TWO-WAY POST-TENSIONED SLABS WITH BONDED TENDONS

**Discussion of “Two-Way Post-Tensioned Slabs
with Bonded Tendons”/**

AUTHOR’S CLOSURE

Fig. 3—Two-way slab with bonded tendons (ACI 318-11).

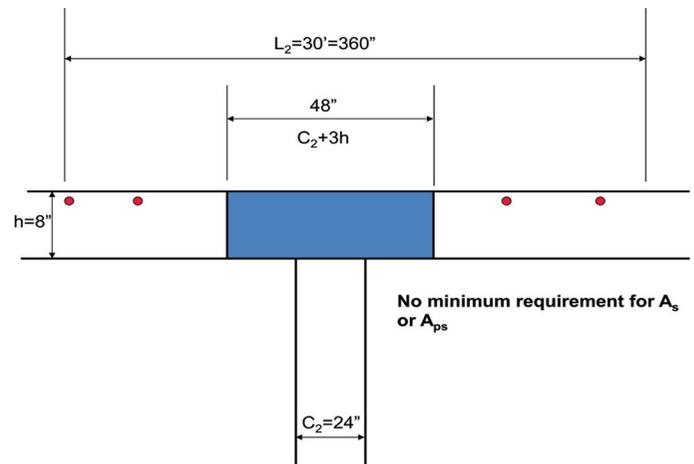
1. Figure 3 presents a possible design scenario for bonded PT slab-column connections that satisfies ACI 318-11.³ No reinforcement is shown in the width of $c_2 + 3h$ or greater, and this is because ACI 318-11³ provides “no minimum requirements for bonded reinforcement—prestressed or non-prestressed—anywhere in the slab for two-way slabs with bonded tendons,” the author stated. However, shouldn’t some bonded reinforcements be located over or near the column to satisfy the minimum spacing requirement for slab flexural reinforcement (ACI 318-11, Section 7.6.5)³ or for temperature and shrinkage reinforcement (ACI 318-11, Section 7.12.2)³?

Referring to the discussor’s first question, ACI 318-11, Section 7.6.5,³ is specifically excluded for all prestressed concrete (refer to ACI 318-11, Section 18.1.3³), and ACI 318-11, Section 7.12.2,³ applies only to one-way slabs (refer to Sections 7.12.1 and 7.12.1.1). So both of the cited Code sections are inapplicable to two-way slabs with either bonded or unbonded tendons.
